weekly notice

Monday, 26 May 2025

RailSafe

REGIONAL INFRASTRUCTURE UPGRADES – NEW INTERCITY FLEET PROJECT BML STAGE 9A2 COMMISSIONING OF POINTS CLEARED 10 CAR SIGN AT VALLEY HEIGHTS STATION, CAR MARKER CHANGES AT VALLEY HEIGHTS, GLENBROOK AND BLAXLAND STATIONS

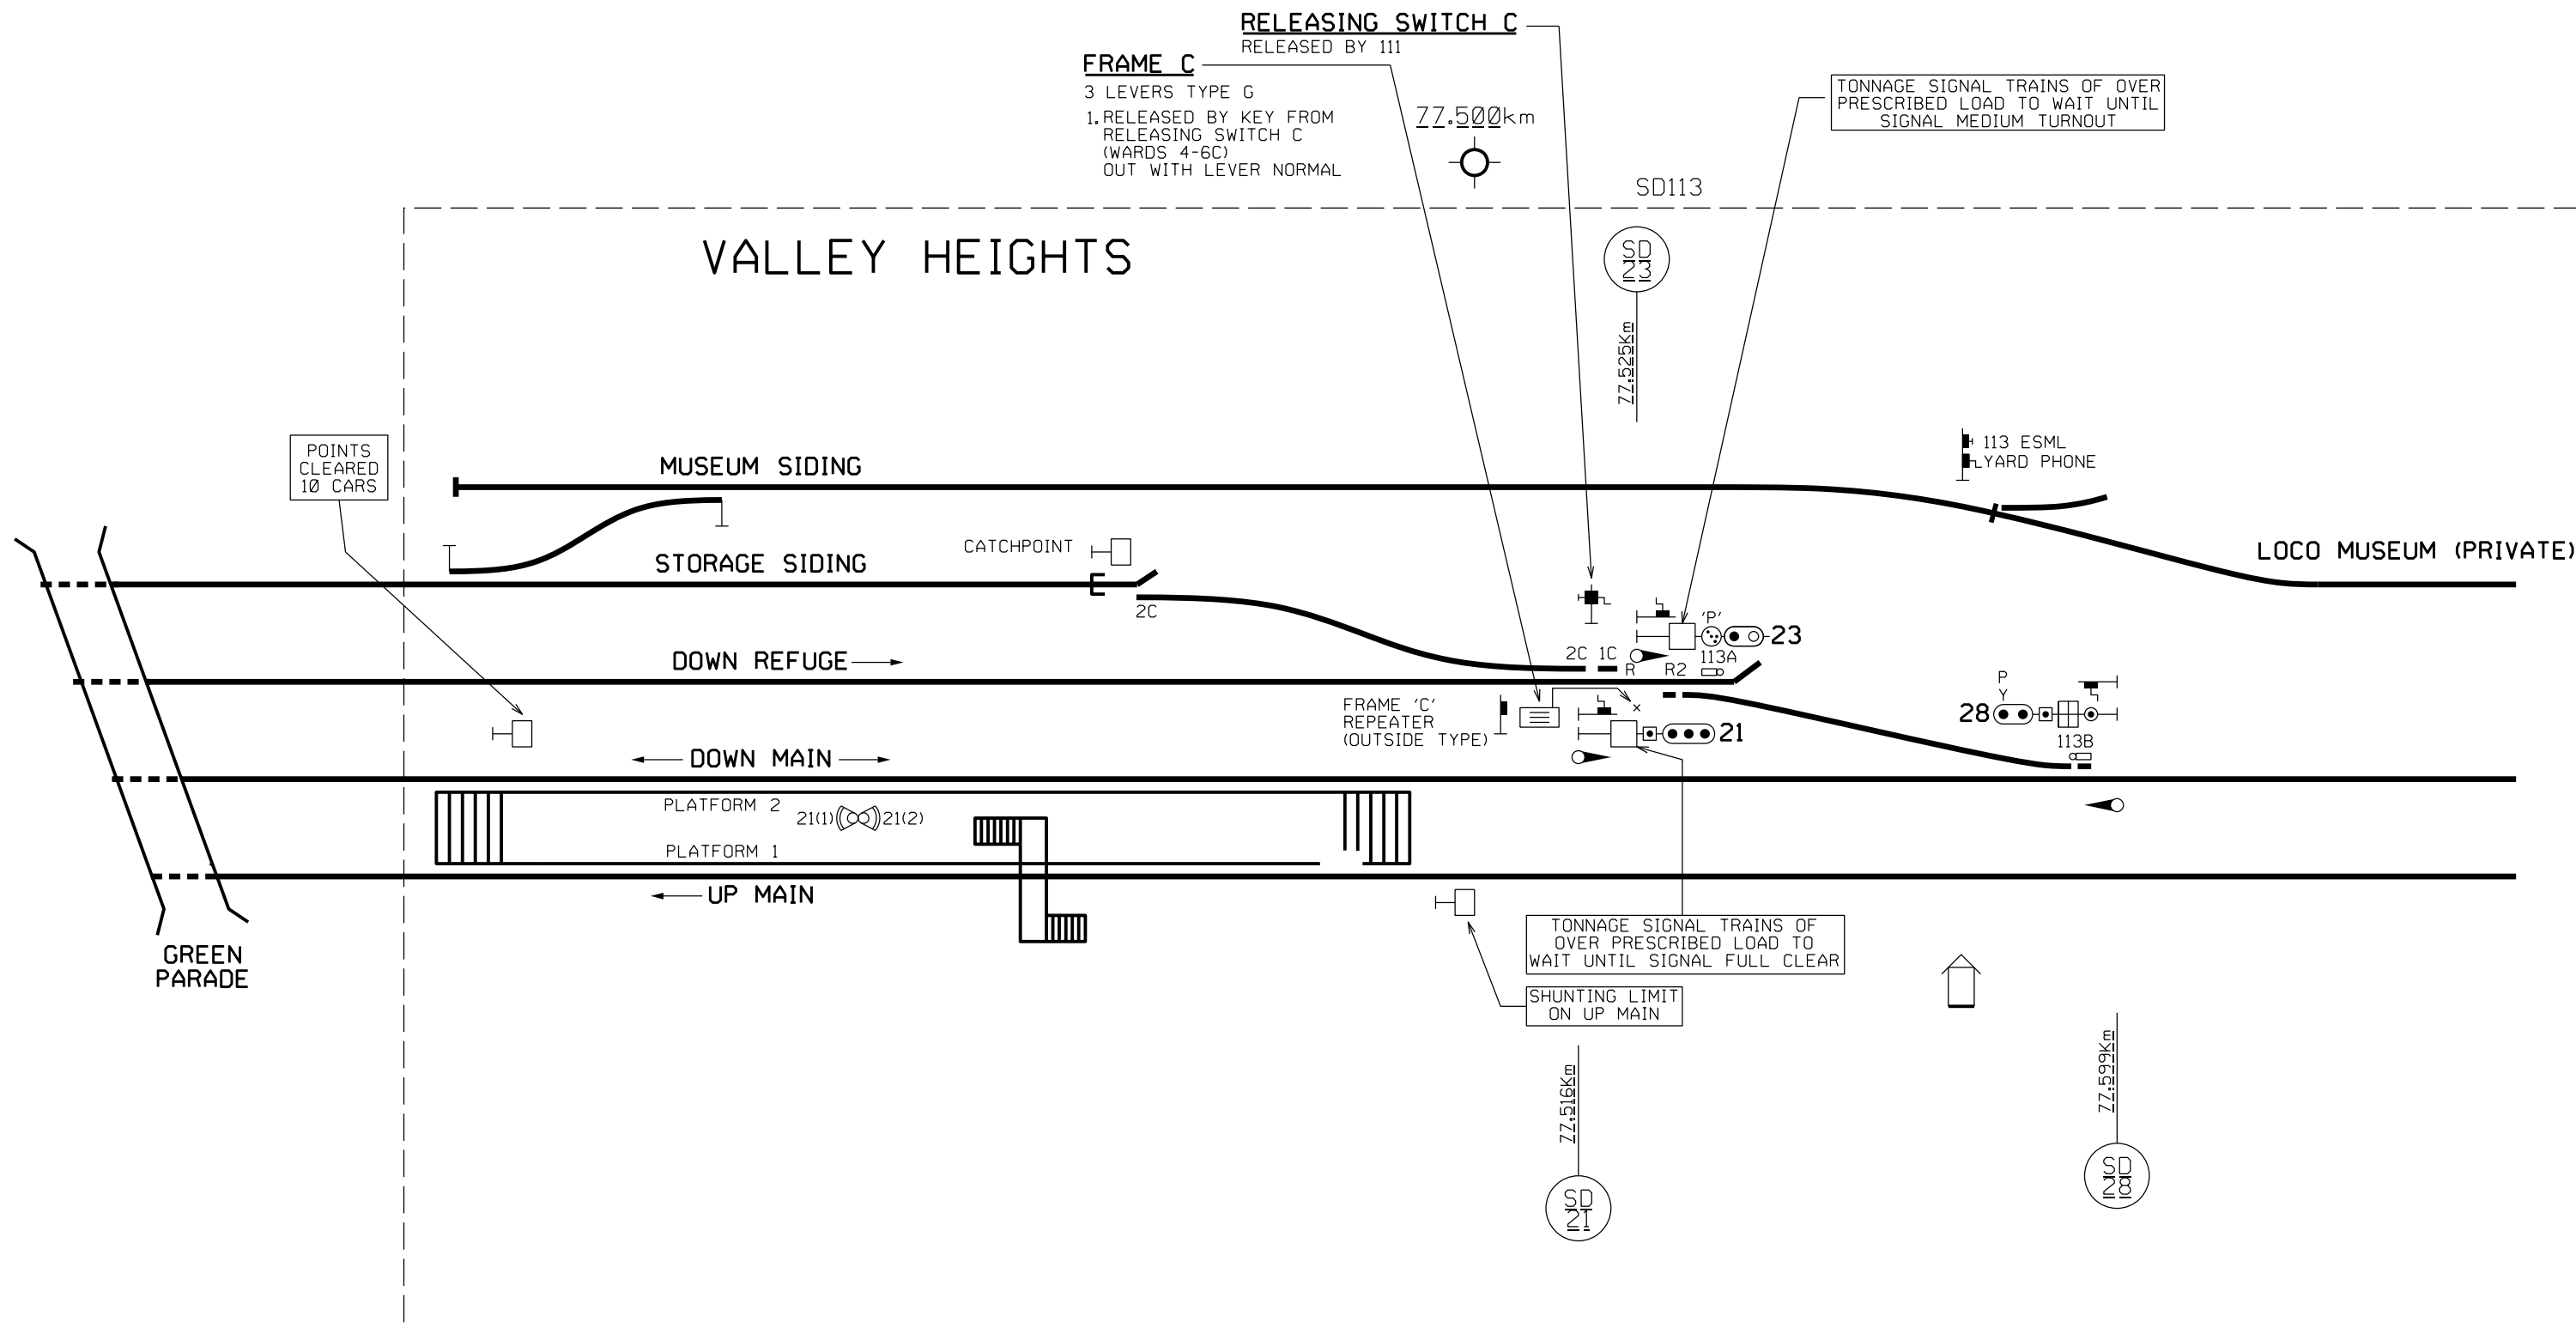
- New platform car marker & trackside stopping sign arrangements will be commissioned at the Valley Heights, Glenbrook and Blaxland stations to accommodate the new 4,6,8 and 10 car NIF trains
- The diagonal white tape shall be removed from car markers installed in an earlier stage. Details listed in table 1.
- Car marker changes as listed in table 02 below.
- Installation of a "POINTS CLEARED 10 CARS" post mounted sign on the DOWN MAIN (within VALLEY HEIGHTS, PLATFORM 2 limits). Sign is located on the left-hand side of the track reading in the Down Direction at approximately 77.331km.
- A Driver's Diagram showing the new Valley Heights arrangement appears in this Weekly Notice.

Station	Platform	Carmarker changes (from the respective platform fenceline)
Valley Heights	1 Sydney End	Existing combined “10/8” carmarker sign on the fence and existing post mounted ‘10/8’ carmarker will be removed and replaced with <ul style="list-style-type: none"> i. New ‘8’ carmarker painted on coping at the fenceline. ii. New post mounted “10” carmarker installed approx. 30.45m to city from the fence.
Valley Heights	2 Sydney End	Existing combined “10/8” carmarker sign on the fence will be removed and replaced with New ‘8’ carmarker painted on coping.
Valley Heights	2 Sydney End	Existing combined “10/8/6” carmarker sign on the fence will be removed and replaced with New ‘8/6’ carmarker sign on the fence.
Blaxland	1 Sydney End	Existing combined “10/8” car marker sign on fence will be removed and replaced with a new “8H” sign on the fence
Glenbrook	1 Sydney End	“4” carmarker on coping relocated approx. 73m from the fence.

Diagram 1: Penrith Car Marker Changes**VER 02052025****Matthew Ward**

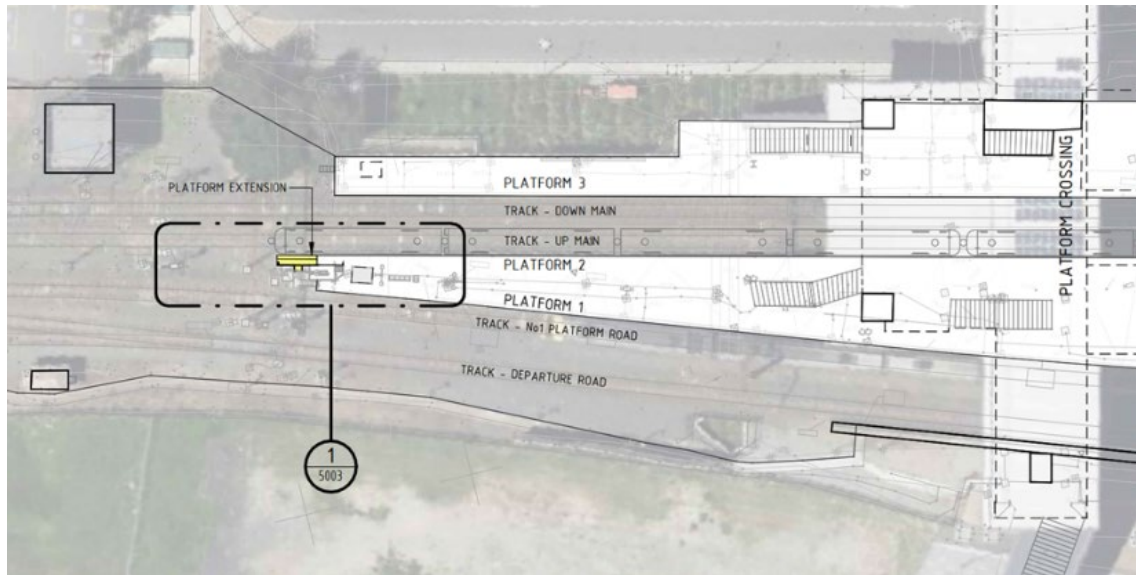
- Construction of a temporary Mariyung Train Guards use only platform extension at the city end of platform 2 at Penrith. Refer to diagram 1 below for details.
- This will be in use until a permanent platform extension is completed in a later stage.
- New platform car marker & trackside stopping sign arrangements will be commissioned at Penrith to accommodate the new 4,6,8 and 10 car NIF trains. Listed in table 1 below.
- Penrith Platform 2 City End “Points Cleared 10 Cars” sign will be removed.

Station	Platform	Carmarker changes
Penrith	1 Sydney End	Existing “8” carmarker sign on the fence and '8' carmarker on the coping will be removed and replaced with new '8' carmarker on coping approx. 2.1m from the fence.
Penrith	1 Country End	Existing '8' carmarker on the coping will be removed and replaced with New '8' carmarker on coping at approx. 2.8m from the fence.
Penrith	2 Country End	New '10' carmarker sign on the new fenceline position for the extended temporary platform.

SYDNEY YARD (CITY EAST) – UPGRADE OF 243A/B & 244 POINTS MACHINES

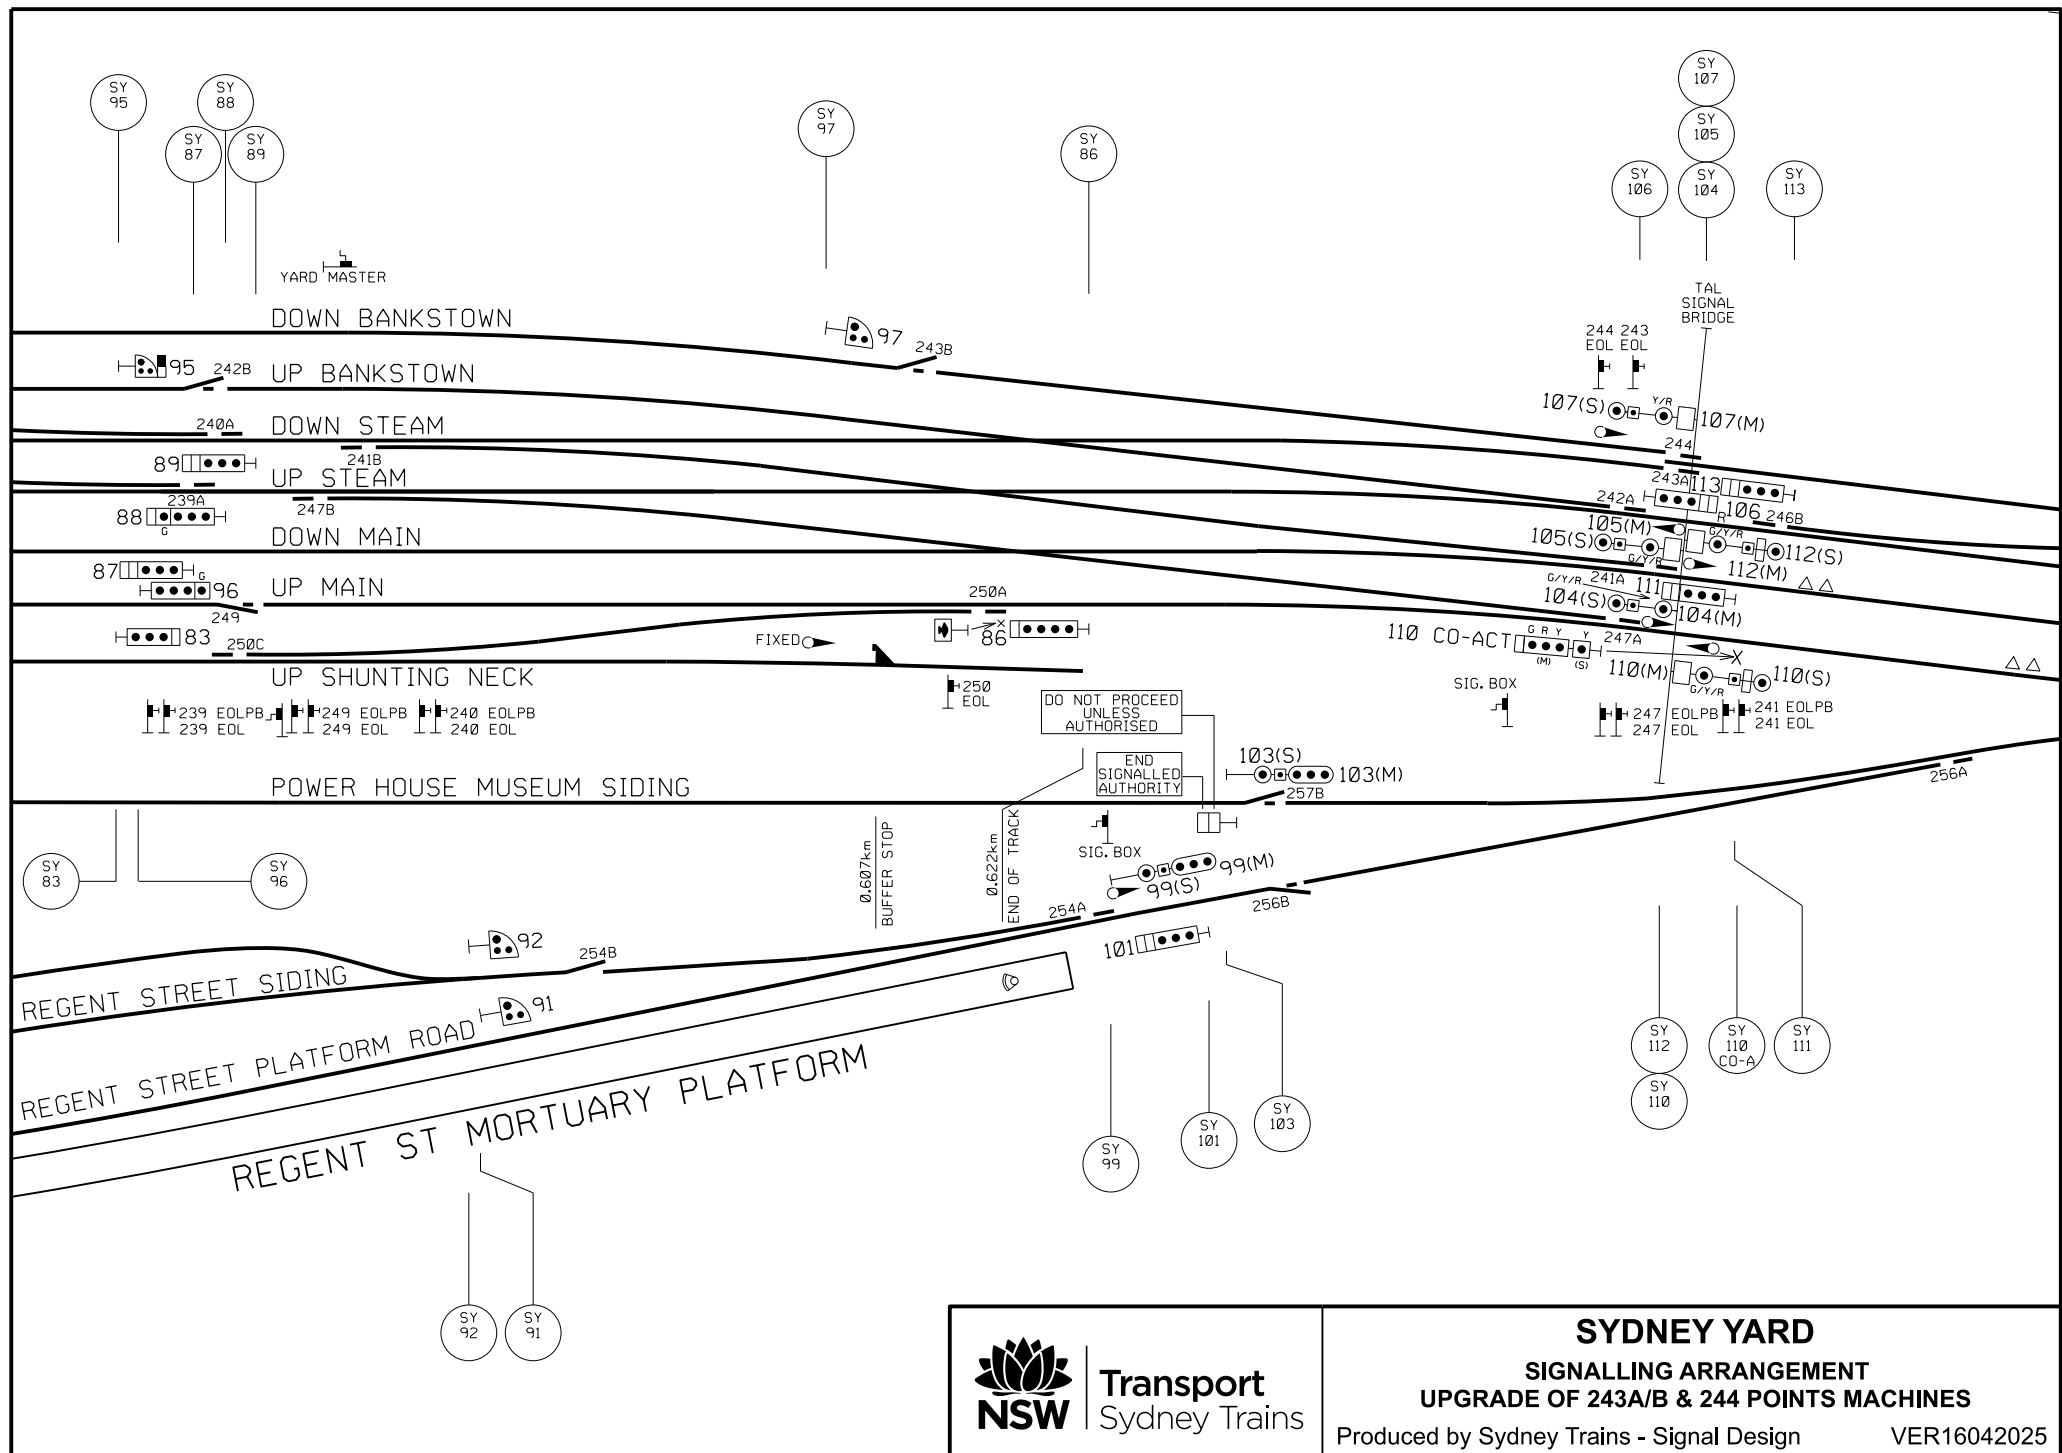
- Existing 243A, 243B and 244 Points machines will be upgraded with an EP “A” style points controller unit with Clawlock arrangement.
- 243A/B & 244 Emergency Operation Lock of the keyless type (EOL) will; be provided on the down side of the Down Bankstown Line, near SY107 signal.
